A G E N D A

Architectural Review Board

August 28, 2018

LAND USE DIVISION

NORMAN BRIDGE Rd. 3123

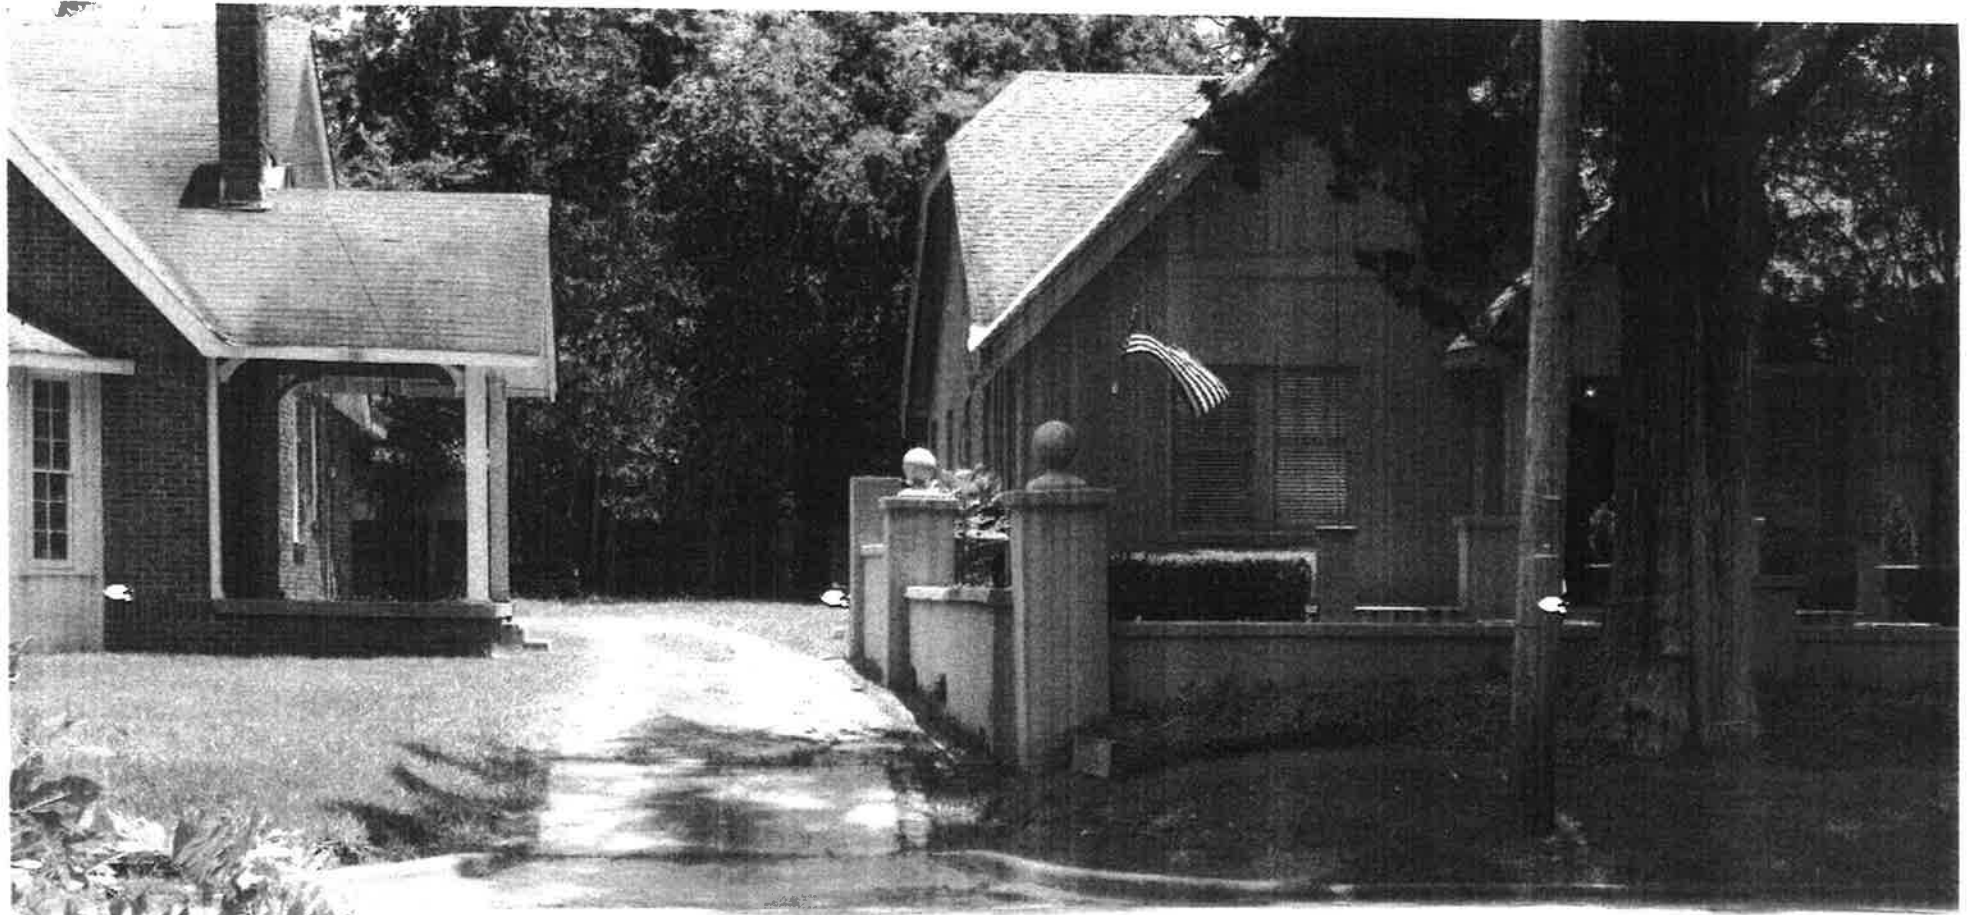
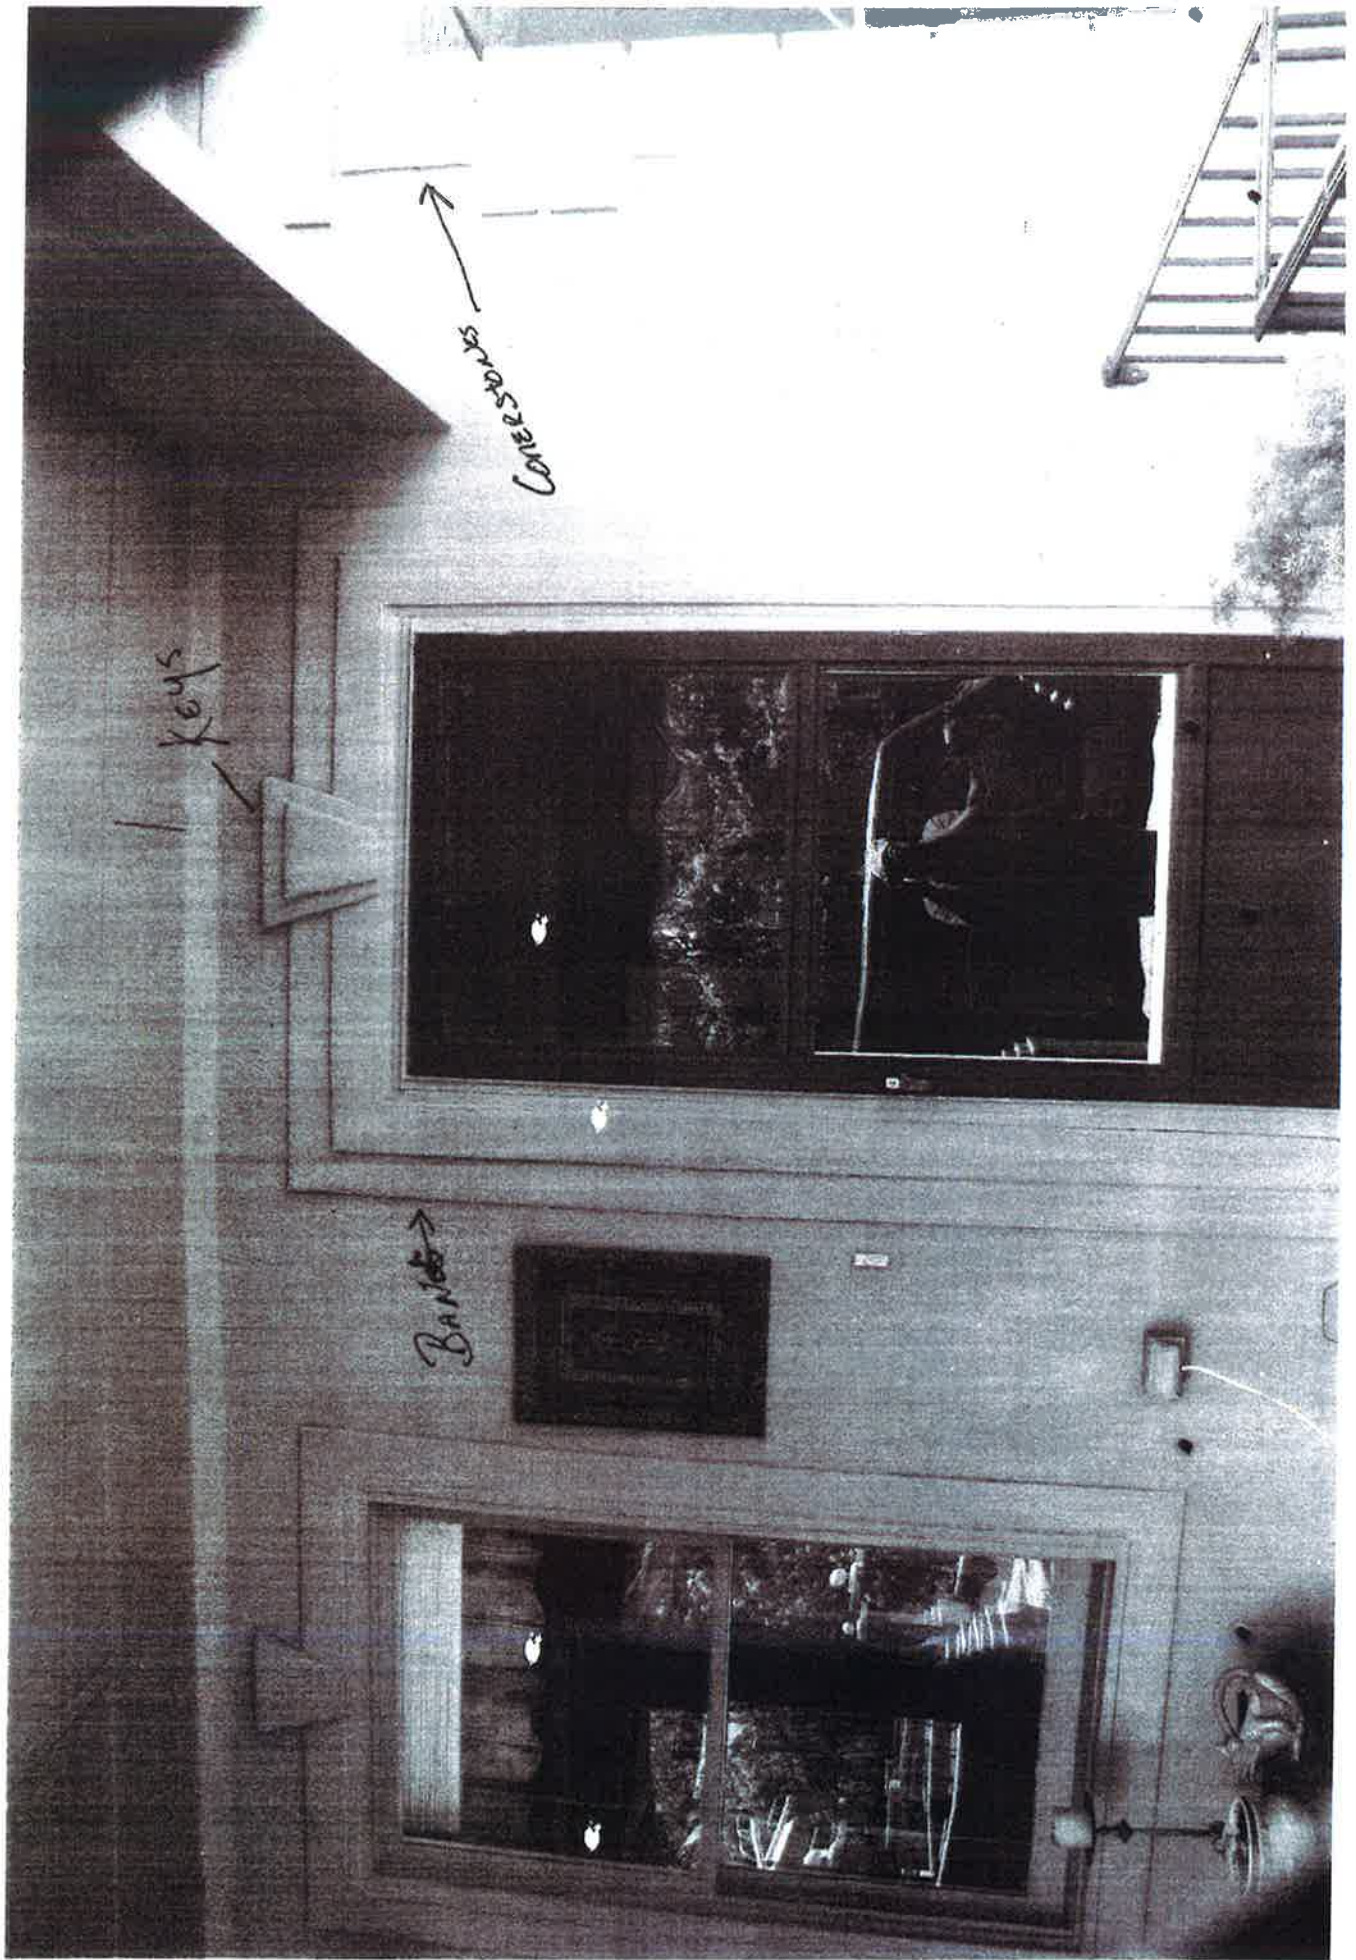
REMARKS: The petitioner is requesting permission to create a new curb cut and driveway on the north side of the property; construct an RV storage building at the rear of the property; and construct a wall on the front property line to match the wall on the adjacent property at 3131 Norman Bridge Road.

- Driveway. Proposed driveway will be concrete, 14' long and extend within 3' of the rear property line.
- RV Storage. The proposed structure will be open at the front and have a 16'x48' footprint, and 16' wall height (no height to ridge given). There will be a square gable vent and a single walk through solid 3' door. A dryvit sand finish to match the house at 3131 Norman Bridge is proposed, matching corner and opening details with keystones, quoins (see accompanying photos). Roof will be shingled in Weathered Wood Architectural Shingle.
- Concrete wall with cap, dryvit sand finish to match existing wall on front property line. Wall height 3'; driveway columns 6'; intermediate columns 4'4".

The Board should disregard the 6' wall proposed in line with the gate at this time. It encroaches on the footprint of the house, which Mr. Harris does not have permission to demolish. Mr. Harris will also need to visit the Board of Adjustment to request variances for coverage, wall column height, and setbacks.

- The Board needs to determine if the scale, material, and placement of the RV storage building is appropriate.
- New curb cut needs to meet City Engineering's turnout requirements.
- There is no record of the wall Mr. Harris wants to match at 3131 Norman Bridge Road having been approved by ARB or Board of Adjustment. It was not in the photos at the time of his 2004 submission to building a garage.

3184 Lexington Road

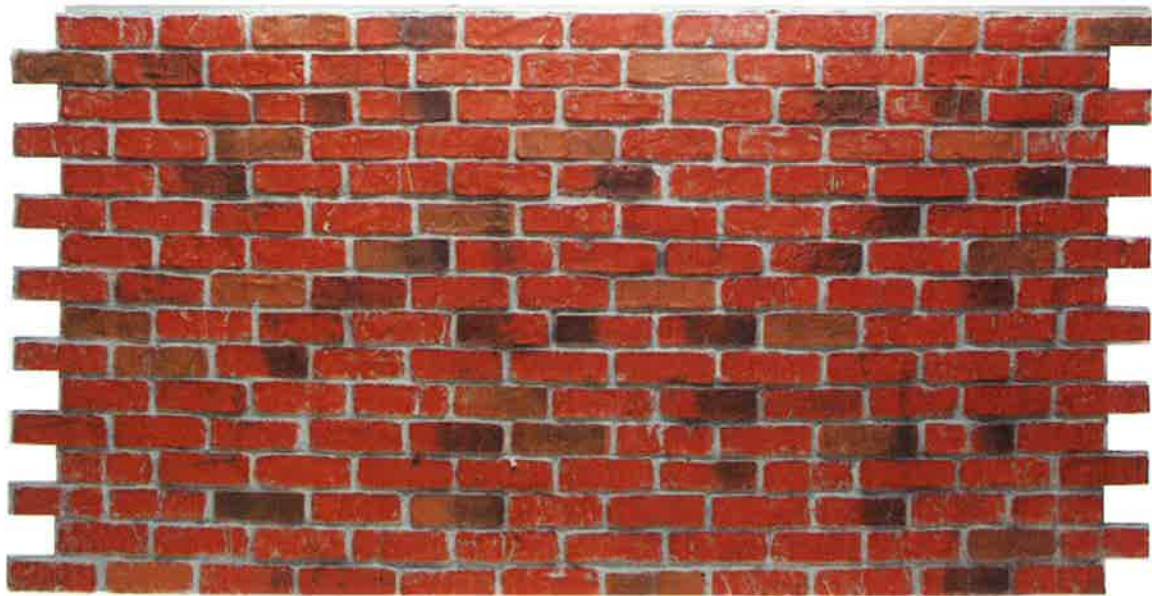
The owner of 3184 Lexington Road inquired about using a faux brick to clad a metal garage. <http://urestonepanels.com/products/used-brick> The house is brick, a sample of the material will be brought to the meeting for your feedback.
